Manufacturer Product Service Bulletin

Number CW03-01

Subject: Capewell Supplied Pins and Ripcords

Status: MANDATORY TEST – This is a one-time TEST. One of the two tests (either TEST 1 or TEST 2) must be performed and marked per test procedure.

Broken Ripcord Pin

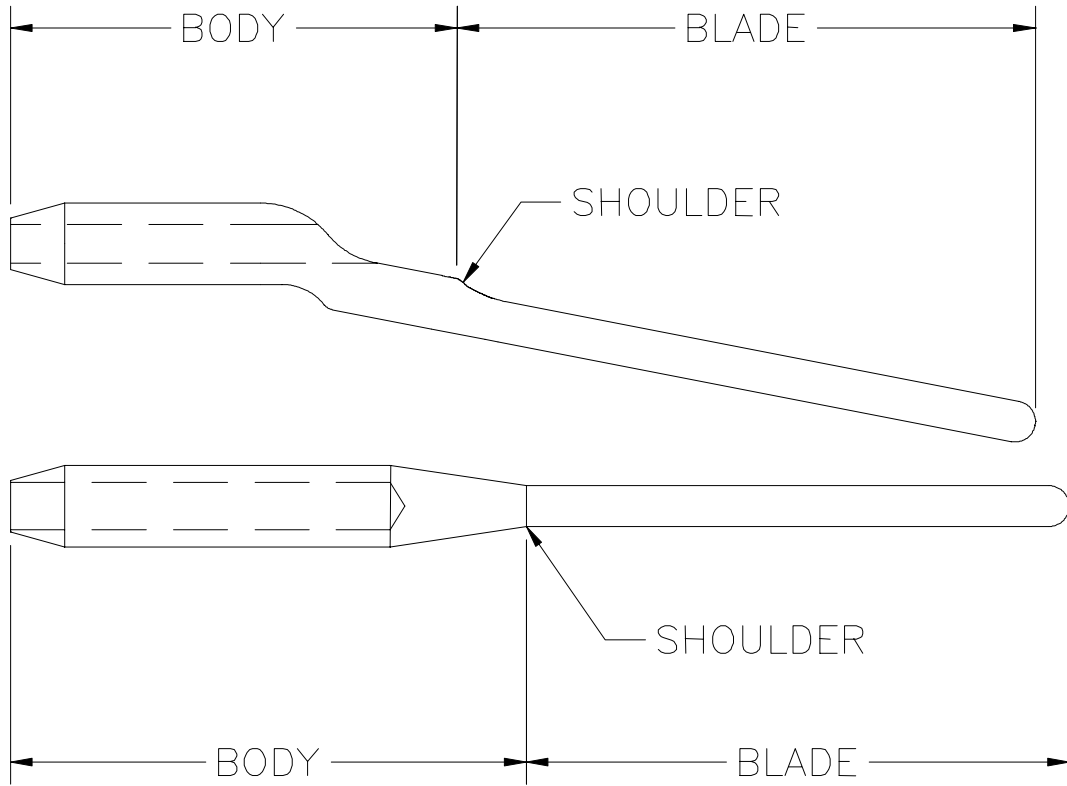
Capewell Components LLC has received (3) reports from (3) customers of (4) ripcord pins that broke. All (4) pins were reported to have broken under very low force. All (4) pins are reported to have broken on the blade section of the pin, approximately 1/8" (3 mm) from the shoulder of the pin. A broken pin is pictured below.

Affected Ripcord Pins are: MS70107 (angled), PS70107 (angled), 61C4304 (angled); 55A6480 (terminal)

WARNING: A DEFECTIVE PIN COULD CAUSE A PARACHUTE SYSTEM TO MALFUNCTION

FIGURE 1

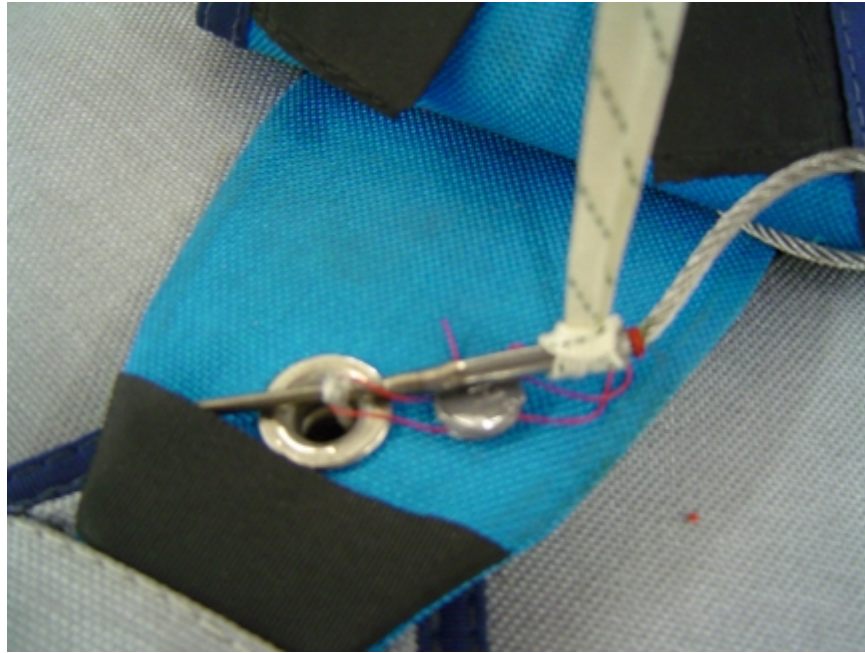
3. Take the suspension line and tie the two ends together with an overhand knot forming a loop.
4. Route the loop around the body of the pin to form a lark's head knot as close to the cable entrance end of the pin body as possible (Fig. 1).

5. Secure the other end of the loop to the spring scale.
6. Apply a load of 15 lbs. (6.8kg) straight up and 90 degrees to the axis of the pin for a period of 3 seconds and then release the load (Fig. 2). Inspect the pin for any deformation or bend. If the pin is straight, continue with step 7 below. If the pin is not straight, as visible without magnification, remove the pin/ripcord from service immediately.

FIGURE 3
All dimension in inches

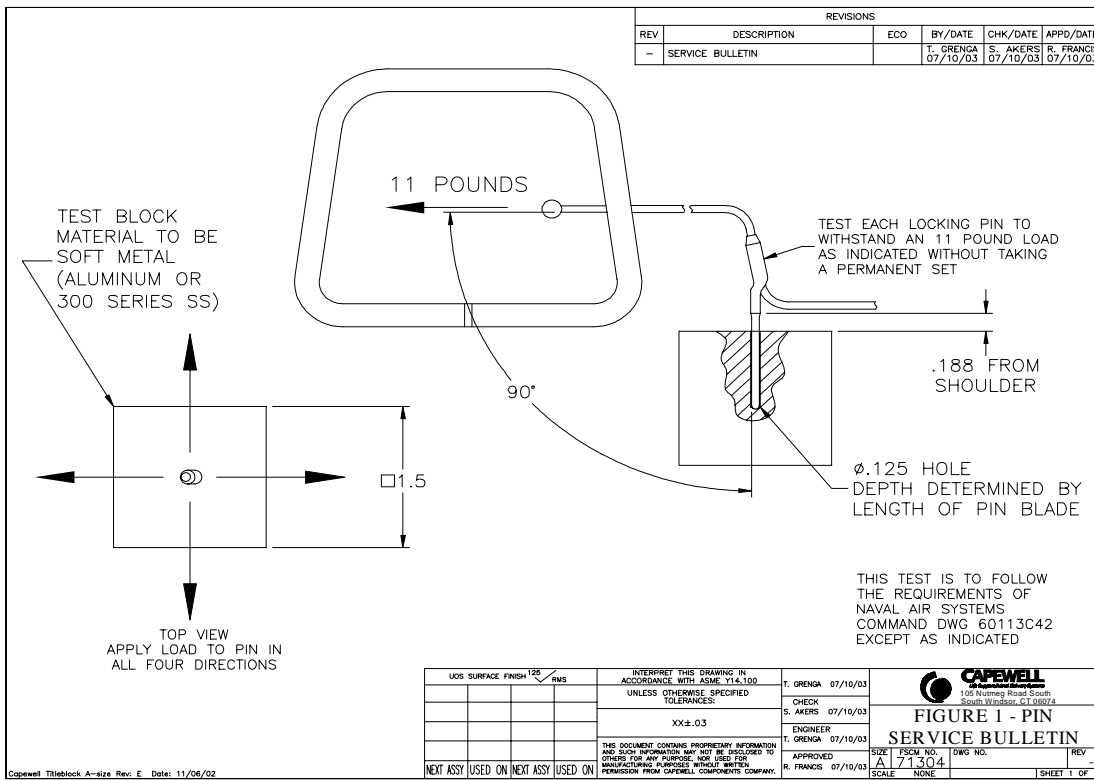
1. Place pin in test block per Figure 3 (below). NOTE: The pin block hole may be VERTICAL or HORIZONTAL
2. Apply 11 lb. force 90 degrees perpendicular to the pin blade.

3. Remove pin from block and inspect:
 - For straightness: Pins in excess of .005 (.12 mm) deformation along the blade of the pin should be removed from service.
